BOUNTIFUL CITY
PLANNING COMMISSION AGENDA
Tuesday, December 19, 2017
6:30 p.m.

Item: PUBLIC HEARING – Request for a variance to the required driveway spacing and construction standards and the maximum yard coverage standards
Address: 349 and 339 W 300 North
Author: Chad Wilkinson, Planning Director
Date: December 19, 2017

Item: PUBLIC HEARING – Request for a variance to allow for encroachments on slopes exceeding 30 percent and to allow for cuts and fills and retaining walls greater than 10 feet in height .
Address: 2452 Cave Hollow Way
Author: Chad Wilkinson, Planning Director
Date: December 19, 2017

SITE PLAN
 11/24/2017
 349 W. 300 H., BANTON, VT.
 VARIATIONAL APPLICATION
 ADDITIONAL OFF-STREET PARKING
 KENNIS RESIDENCE

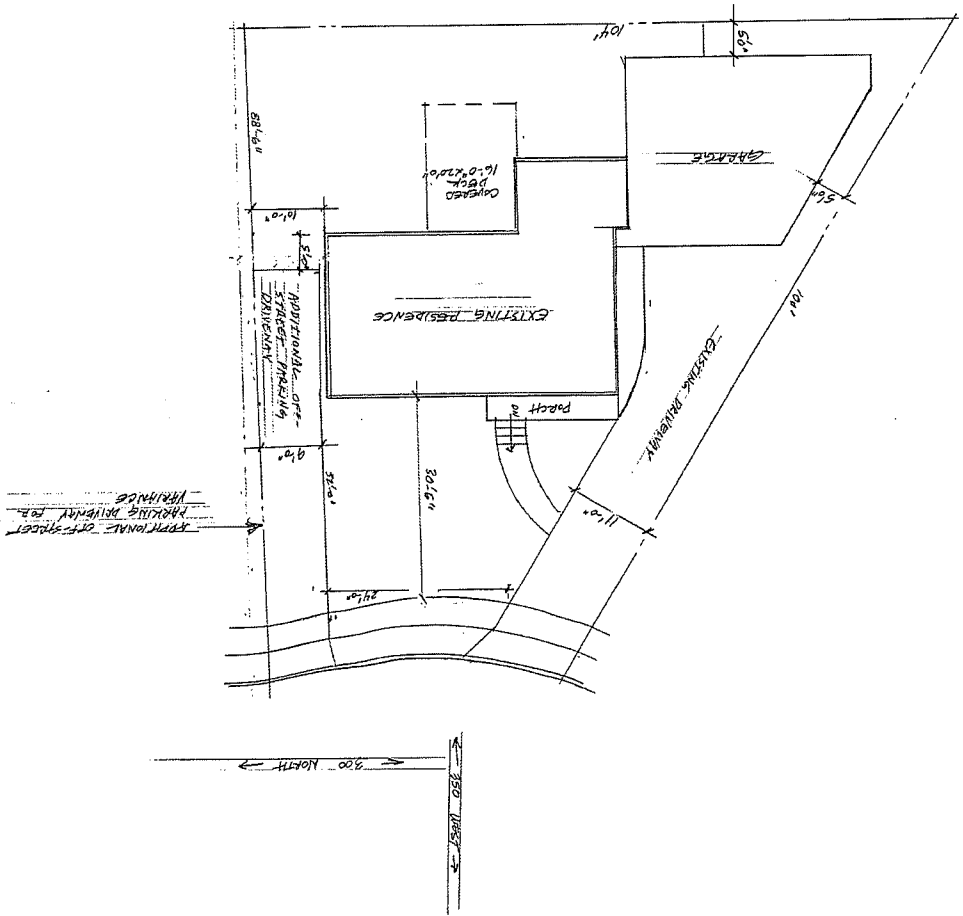
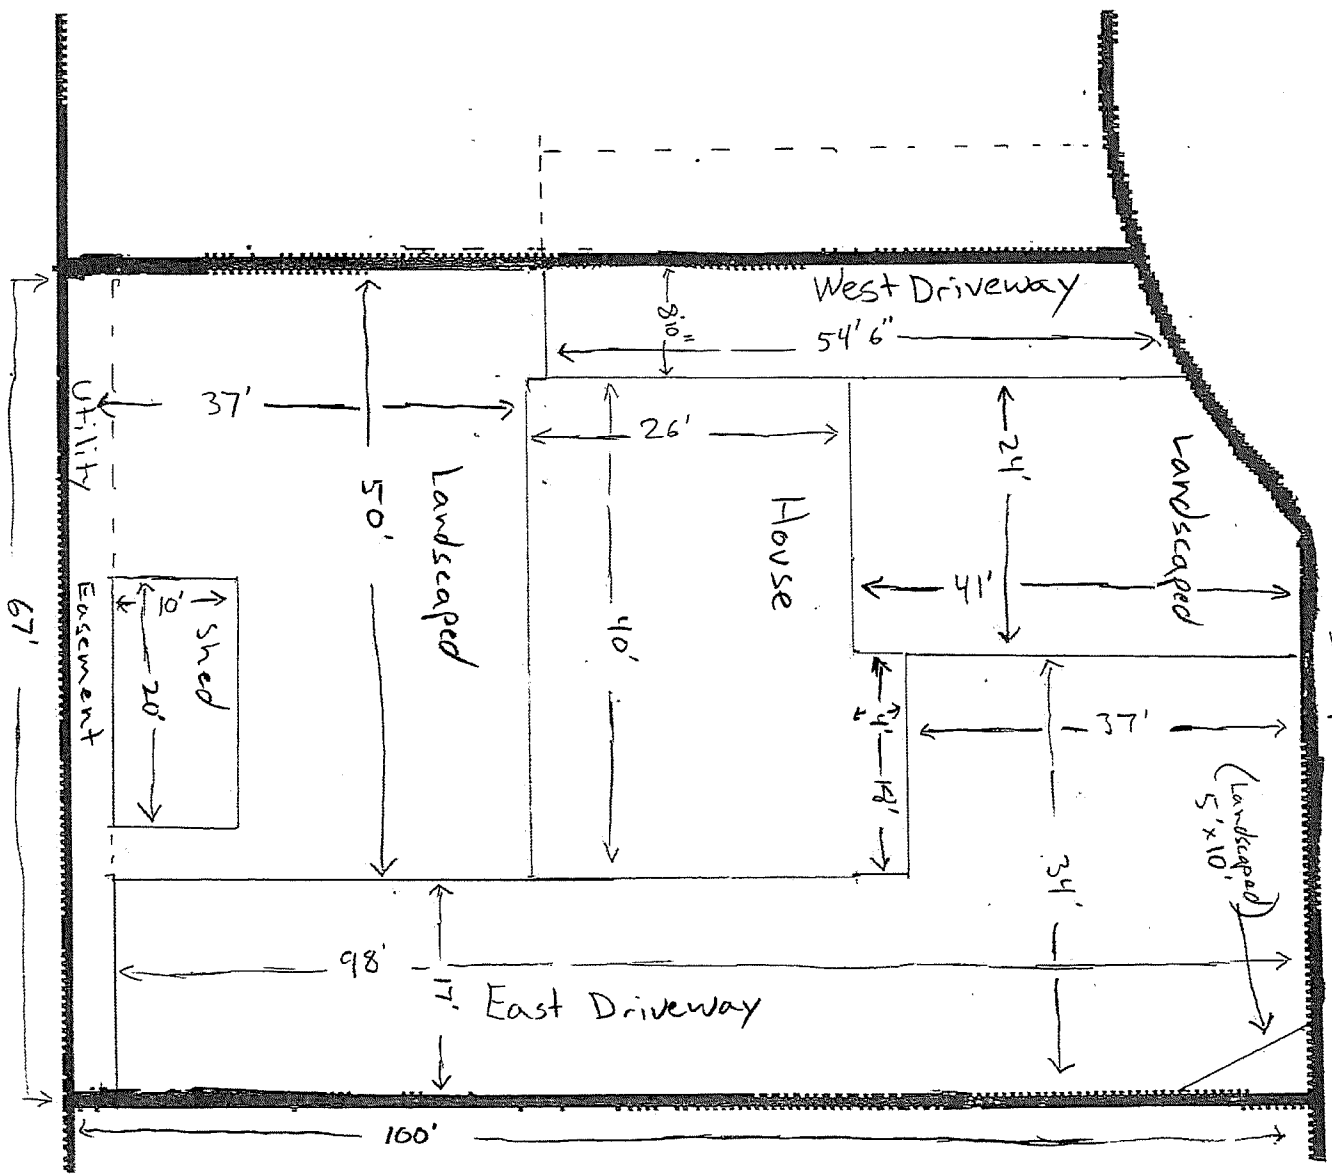
The applicants are requesting a variance to allow for a shared driveway between their properties. The driveway has already been installed and was constructed without proper permits from the City. Mr. Lee recently constructed a permitted driveway on his property and a follow-up inspection on this driveway prompted the enforcement action that resulted in the application for variance. The zoning ordinance requires a minimum separation of 35 feet between driveways on the same property and a minimum 5 feet separation between driveways and the adjacent side property line. The proposed driveway is located approximately 24 feet from the existing driveways on both the Lee and Minnis properties and therefore does not meet the minimum 35 foot separation standard for either property. The driveway also does not meet the minimum 5 foot separation requirement between driveways on adjacent properties.

In addition, the construction of the driveway has caused both properties to violate the maximum yard and lot coverage standards of the Code. The front yard of the Lee property has approximately 67 percent impervious coverage which exceeds the 50 percent maximum. In addition, the property exceeds the maximum lot coverage standard of 60 percent. The Minnis property also exceeds the required lot coverage with the construction of the driveway. The calculations submitted by Mr. Minnis do not include a large covered deck at the back of the house which must be counted toward the lot coverage standard. The calculations performed by staff and the applicants differ. However, with the inclusion of the covered deck, both staff and applicant calculations verify that the lot coverage standard is exceeded on both lots and that the front yard coverage standard is exceeded for the Lee property.

The applicants have requested an additional variance to the Engineering specifications for driveways related to required curb cut and driveway approach standards. This standard is not part of the land use ordinance and may not be varied by the Planning Commission. Any resident wishing to access the public right of way must do so with a City standard approach.

Staff recommends denial of the requested variance, based on analysis of the required review criteria from State law included in the findings above and a review of the materials submitted by the applicant.

SLOPE ANALYSIS
C2.03

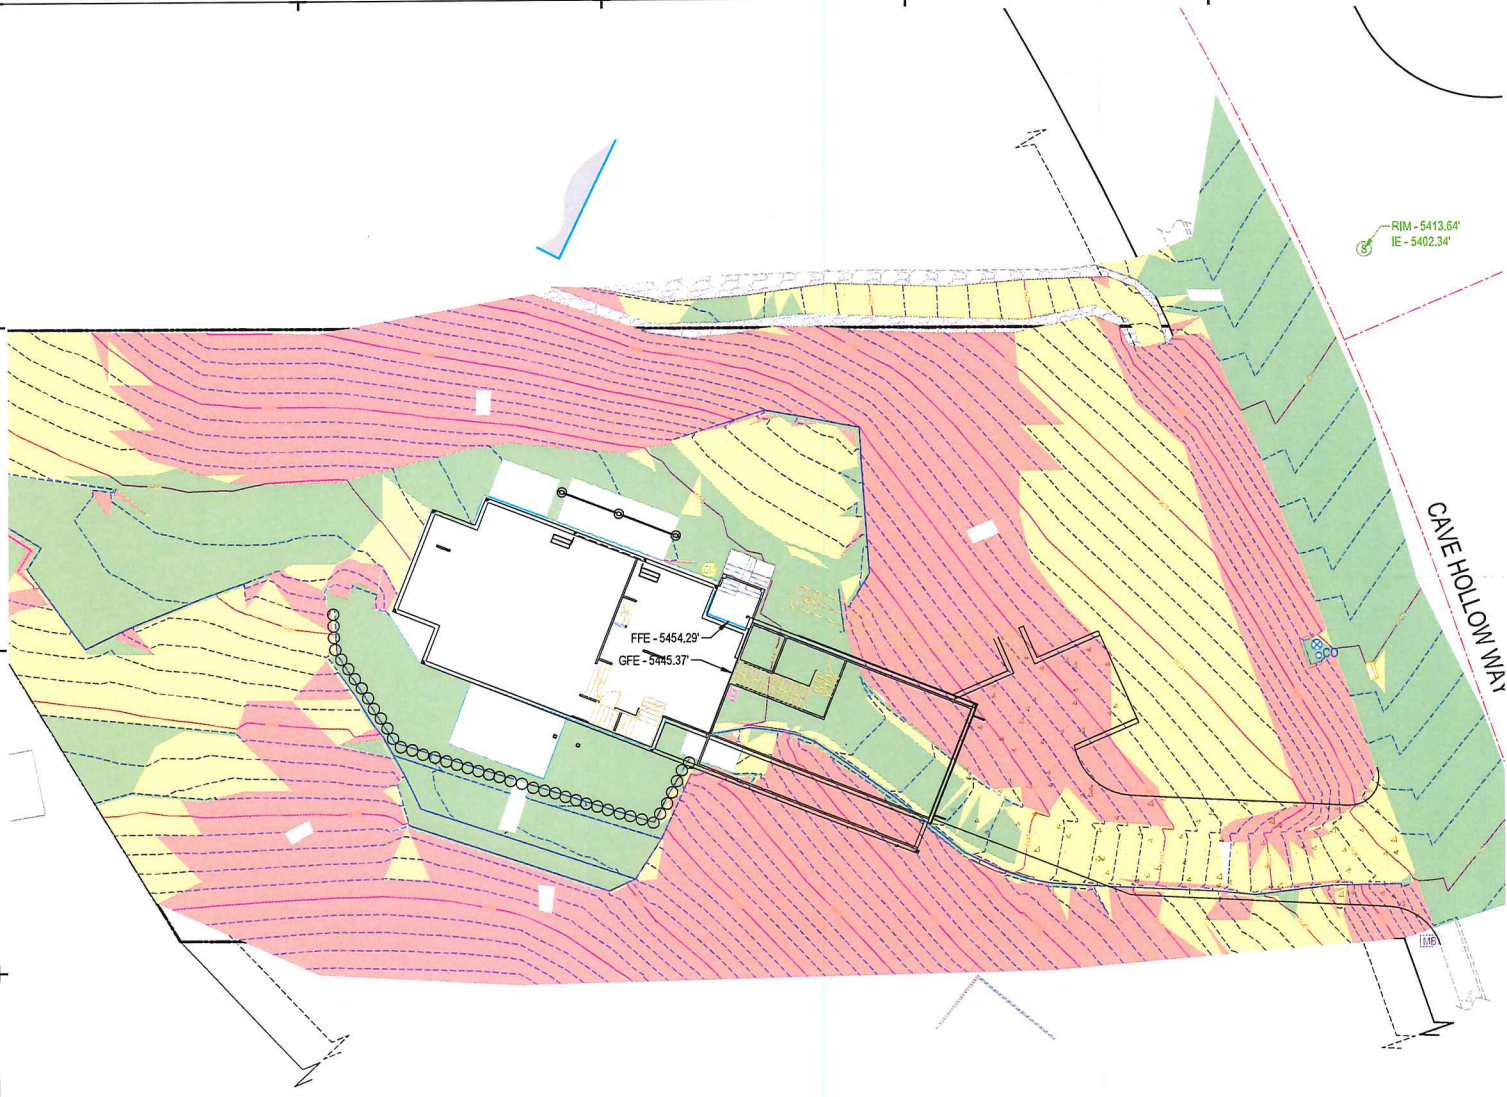
The existing home on the site was constructed in 1978 with a two car garage. The current request is to allow for construction of a three-car garage with two stories of living space above. The request also includes grading and site work necessary to lower the driveway in order to provide a less steep access to the property. The driveway is currently quite steep with an average slope of 19 percent and a maximum slope of 26 percent. The proposal would bring the maximum slope down to 10 percent and the average slope to 8 percent. The predominant issue is the size and extent of the area to be disturbed in order to lower the driveway and construct a new garage. The applicant proposed three-car garage is 42 feet by 20 feet and includes space for an elevator and a large staircase. Above the garage the applicant proposes two stories of living space measuring 42 feet by 28 feet. The proposed addition will nearly double the size of the structure. The addition encroaches into areas of 30 percent slope adjacent to the existing driveway.

The applicant also proposes a turnaround parking area near the proposed garage that will further encroach into slopes exceeding 30 percent. A stairway connecting the entrance of the home to this parking area further encroaches into the constrained area of the lot. The applicant has provided a slope analysis drawing that shows the area of encroachment which is attached to this report.

In addition to the encroachments into steep slope areas the applicant proposes a series of major cuts on the site that will result in the need for tall retaining walls. The plan shows one wall approaching 17 feet in height. The proposed cuts will be up to 15 feet in height in order to accommodate the driveway and garage.

Staff recommends denial of the requested variance.
